METALLURGICAL EXAMINATION & REVIEW
OF
CASTING DEFECTS
IN THE
STAINLESS STEEL VALVE BODIES
LOCATED IN THE CLASS ONE SYSTEMS
OF THE
OYSTER CREEK REACTOR

No. DC-31

March 3, 1969

Prepared for: AEC Contract No. AT(11-1) - 1658
Task A
Parameter No. 68-69A; Subcontract No. 7

Micrograph of a typical casting defect found in valve number V-20-41 during the metallographic examination performed at APED-GE-San Jose, California. Lightly etched - 250X.

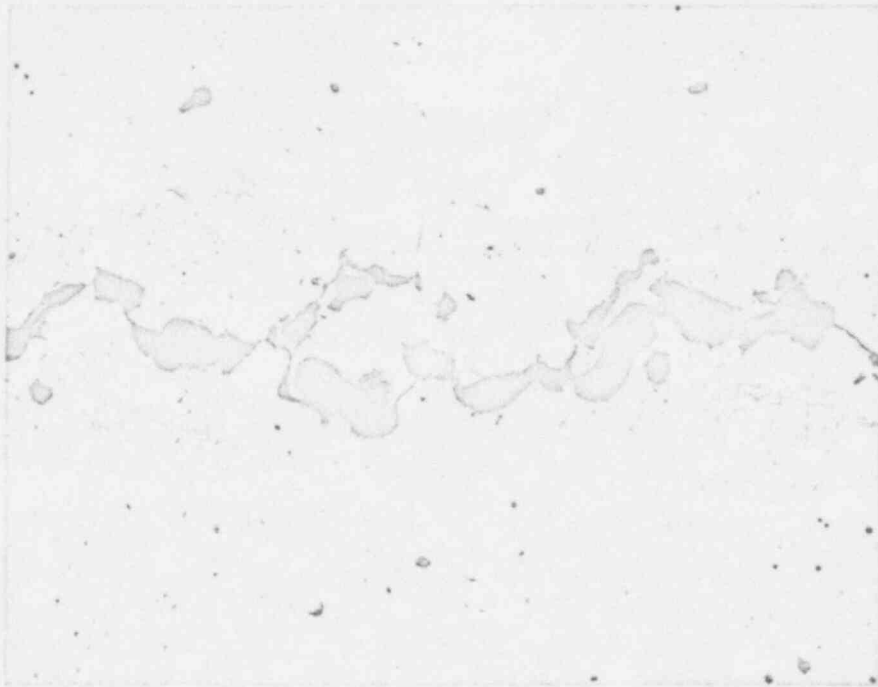
An example of the defects observed in these microsections is shown in Exhibit C. This micrograph shows that these indications are a combination of microshrinkage voids and hot tears. More specifically, it appears that the microvoids (shrinkage) are essentially linked by hot tears. These defects were metallographically observed, in some cases, to be greater than one-inch in length. No evidence of excessive mold-metal reaction was metallographically observed.
